Subject: Submittal of the Draft Removal Action Work Plan, Union Pacific Railroad Beverly Hills Site, Beverly Hills, California

Response to Comments Regarding the
Draft Removal Action Work Plan, Union Pacific Railroad Beverly Hills Site, Beverly Hills, California (Removal Action Work Plan [RAW])
dated August 3, 2020

from
California Environmental Protection Agency, Department of Toxic Substances Control (DTSC)

Figure 2-1a
Proposed Sampling Grid
Pre-Construction Investigation Work Plan
Union Pacific Railroad Beverly Hills Site,
9315 Civic Center Drive,
Beverly Hills, California

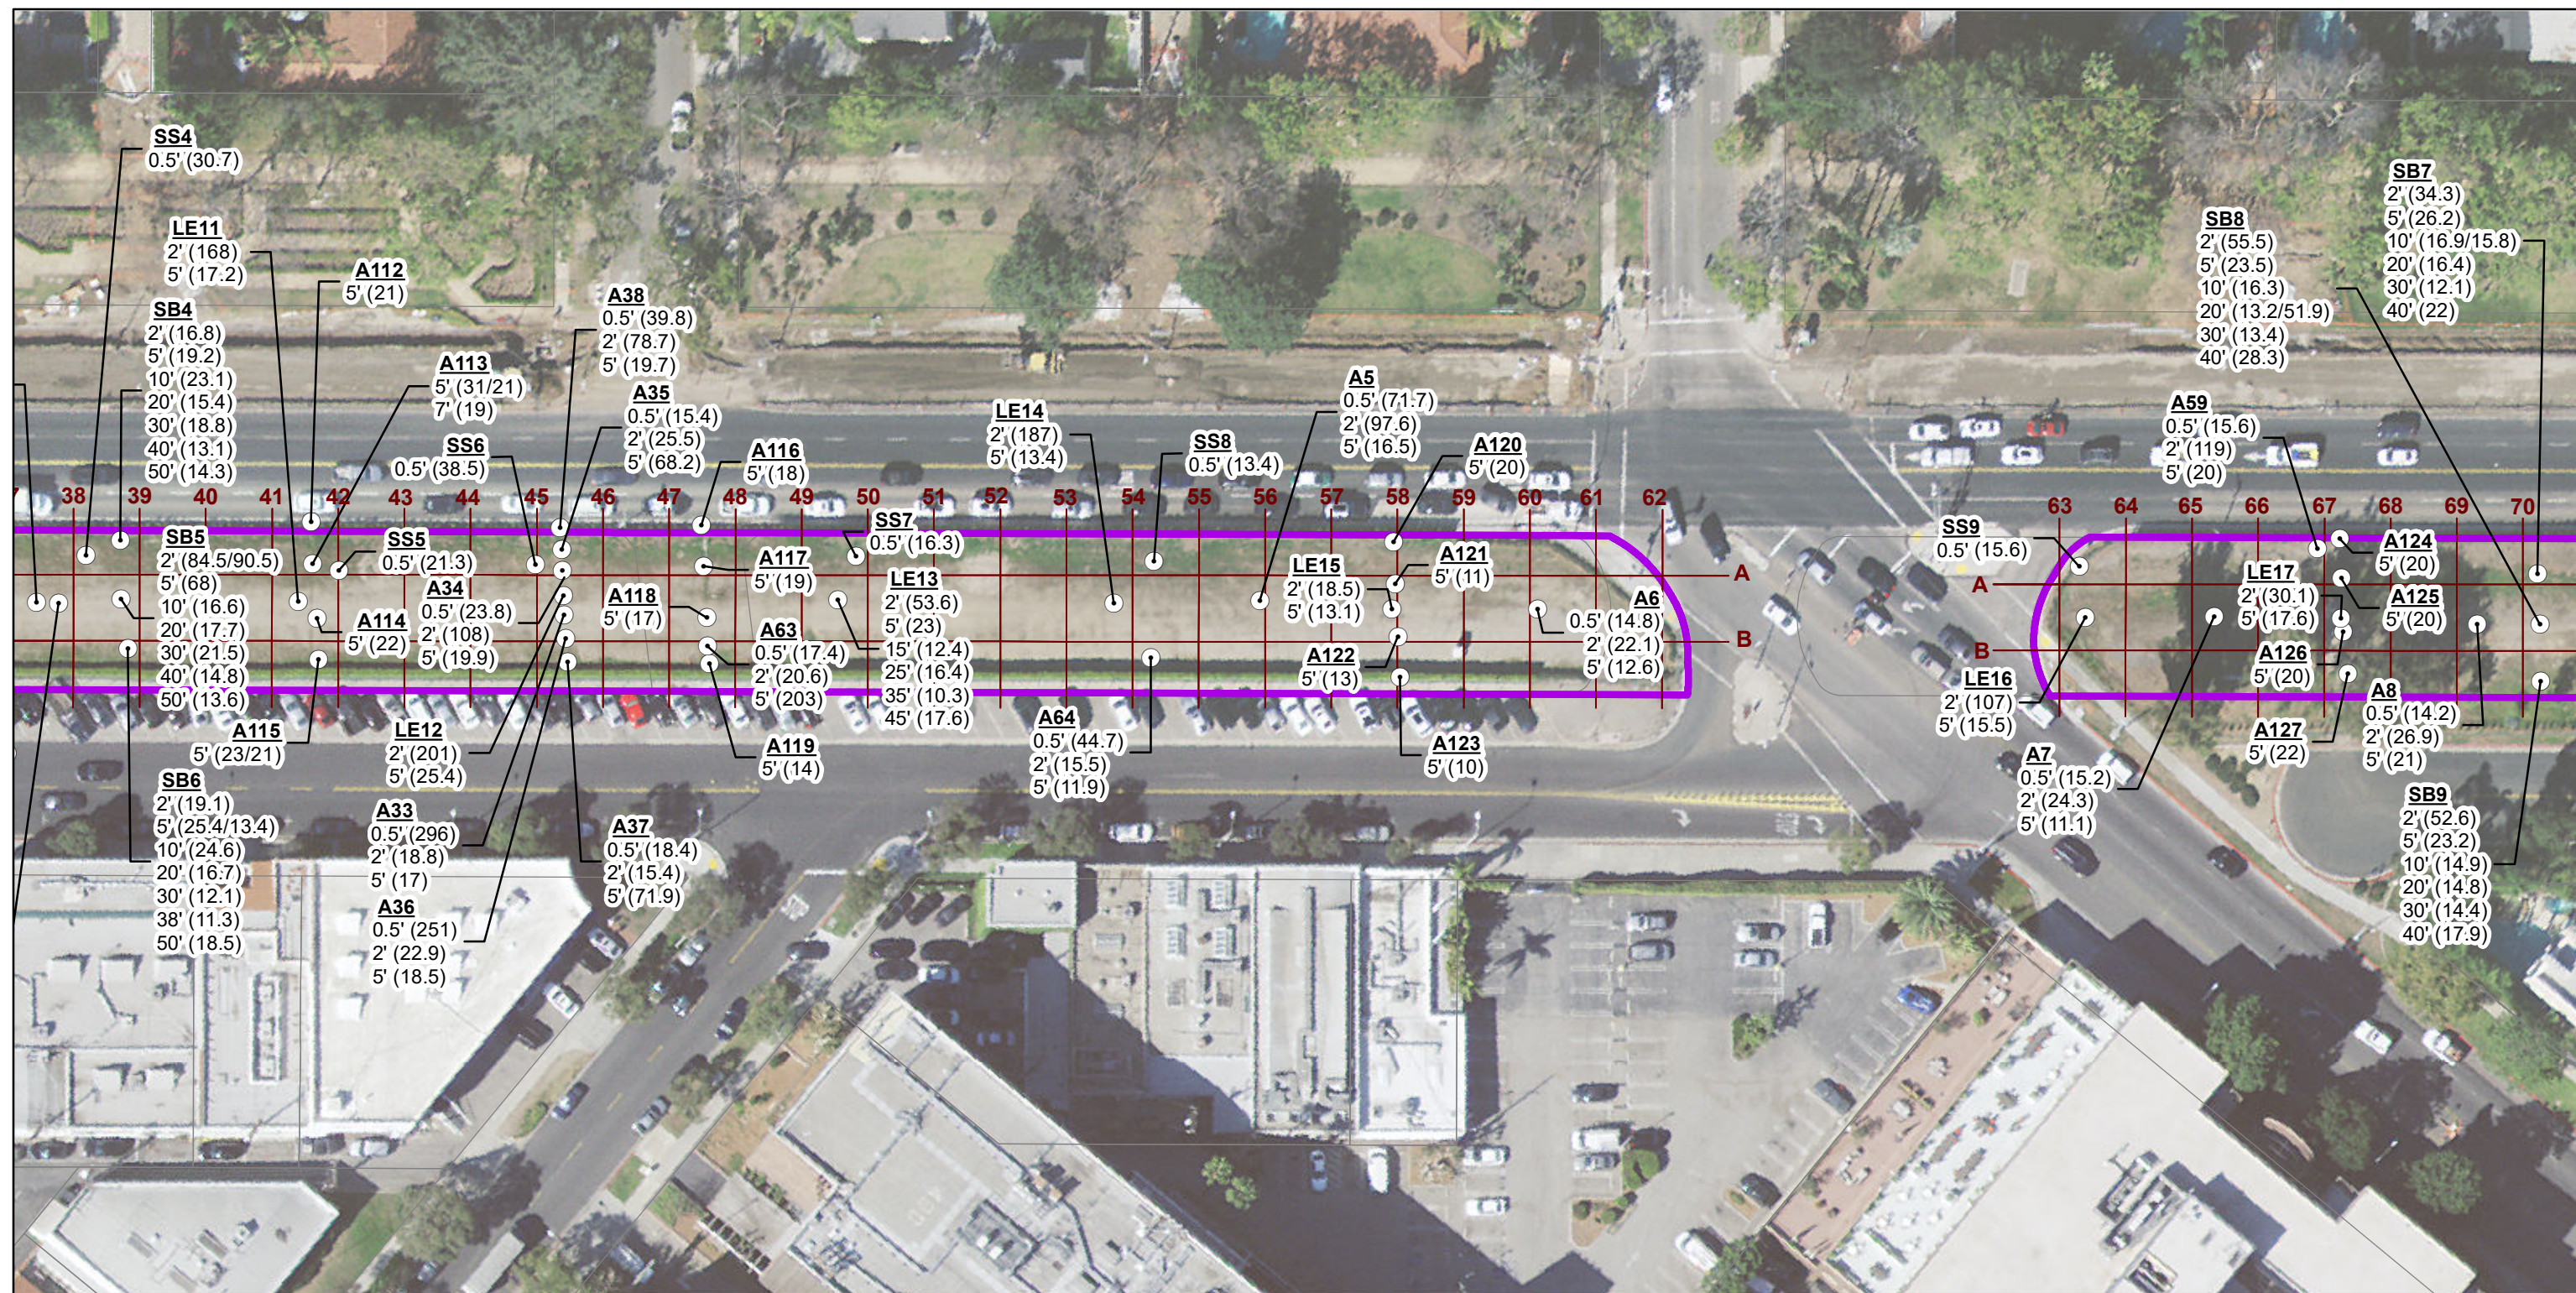
3.		The Appendix F - Pre-Construction Investigation Work Plan indicates that supplemental characterization sampling is to be conducted at 25' intervals. A rationale for this distance should be provided. Note that a rationale for 10' spacing was provided in a memorandum from this geologist dated 3 January 2020 on the 18 December 2019 should be used.	Appendix F (Pre-Construction Investigation Work Plan) has been revised to state that the rationale for the 25-foot spacing is to align with anticipated 25-foot removal action areas. The purpose of the pre-construction investigation is to provide a more refined understanding of the volume of soil anticipated to be impacted and subsequently removed. A 25-foot spacing grid presents a practical approach to meet this objective. Ultimately, the removal areas will be based on the results of pre-construction investigation data and verified using confirmation soil sampling.
